CONSTRUCTION DOCUMENTS
LT 2, BLK 1, AIRPORT INDUSTRIAL
PARK ADD., WICHITA, KS
PRIVATE PROJECT WATER PLANS
KEY MAP NOTES

PRIVATE PROJECT WATER PLANS
LT 2, BLK 1, AIRPORT INDUSTRIAL
PARK ADD. WICHITA, KS

PLAN-PROFILE

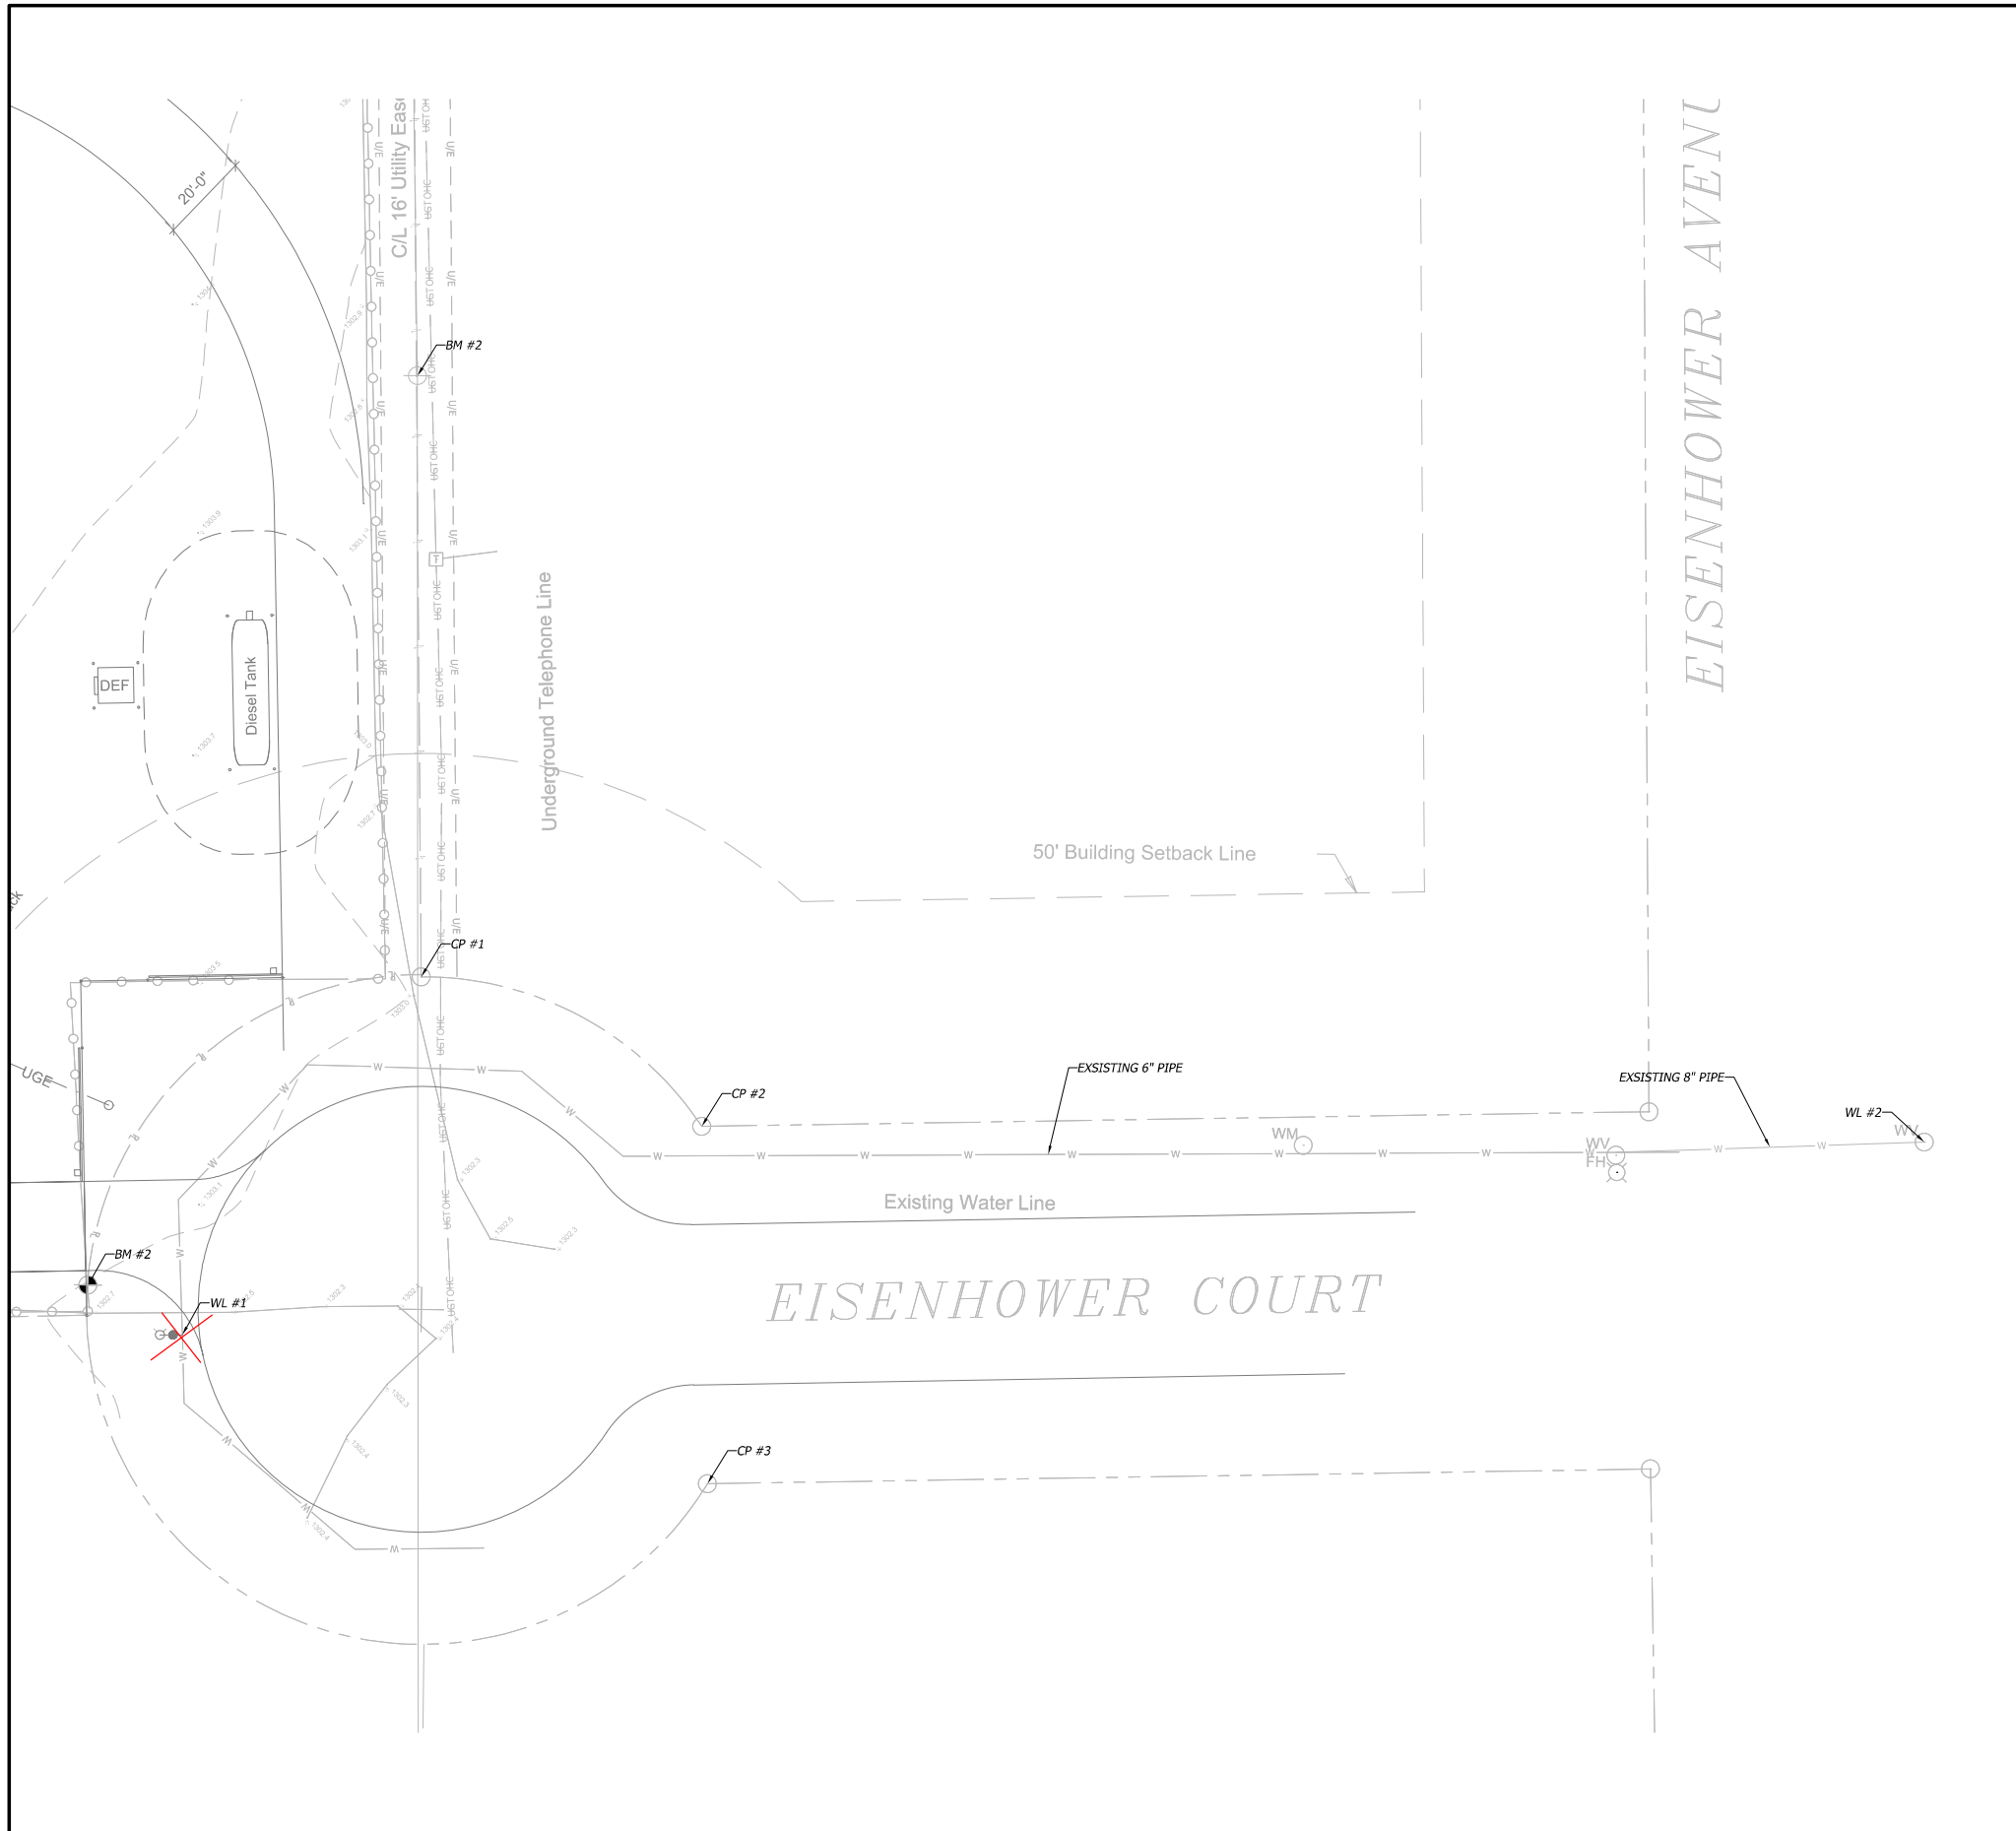
Do Not Use these Coordinates - per Matthew Tucker - via 2-22-24 Email. Use Construction Note Coordinates for TAP Saddle Location. Larry Powell - 2-22-2024
